Addendum 3

TFM-026-24 – L-119-22 QEII Library Level 2 Washroom Renovations

Addendum 2

PROJECT NAME:
**QEII LIBRARY
LEVEL 2 WASHROOM
RENOVATIONS**
Project #: L-119-22

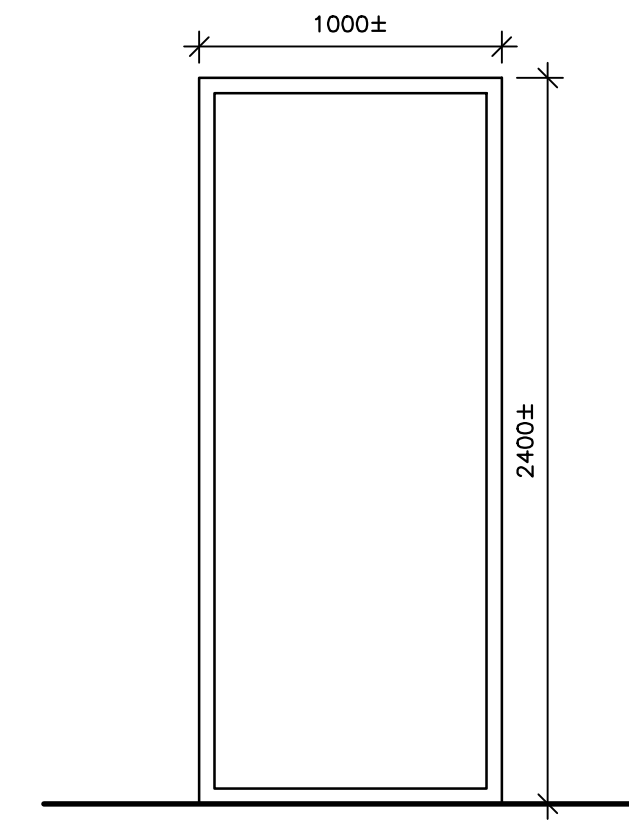
- .2 The new door grille says "See Drawing M-4.0". This drawing is not in the documents. Please provide.

RESPONSE: “See Drawing M-4.0” to say “See Drawing MV-1.0”

MUN PROJECT No. **L-119-22** DRAWING No. **A-3.0**

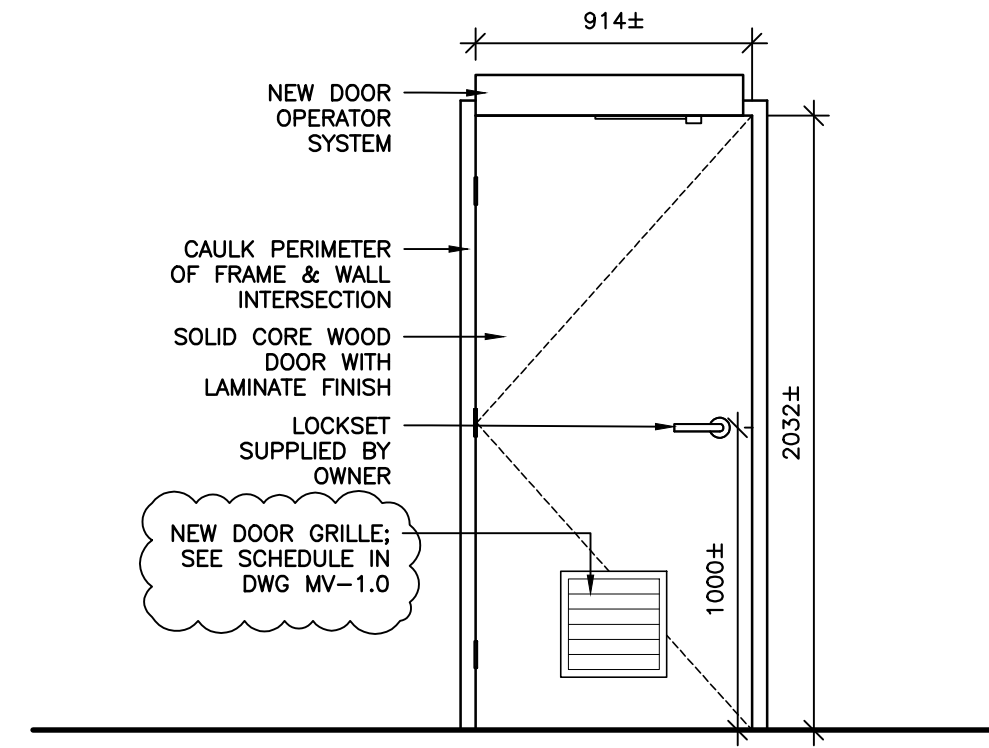
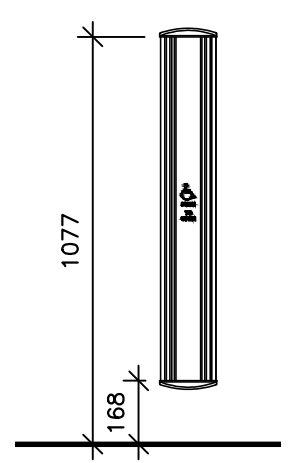
- .1 The Addendum 2 says painted door but the new door schedule again says plastic laminate and the brand of laminate which wasn't there before?

- .1 Delete Drawing A-3.0, R2 Issued for Tender, dated June 7, 2024, and replace with the attached drawing A.3.0, R3 Issued for Addendum 2, date June 26, 2024.

- .1 On the door schedule it specifies the wood door is to be painted. However, Elevation 1 describes the wood door with a plastic laminate finish. Please clarify.

RESPONSE: As per re-issued drawing A-3.0, R2, door finish to be plastic laminate.

RESPONSE: As per the door schedule, wood door to be painted finish
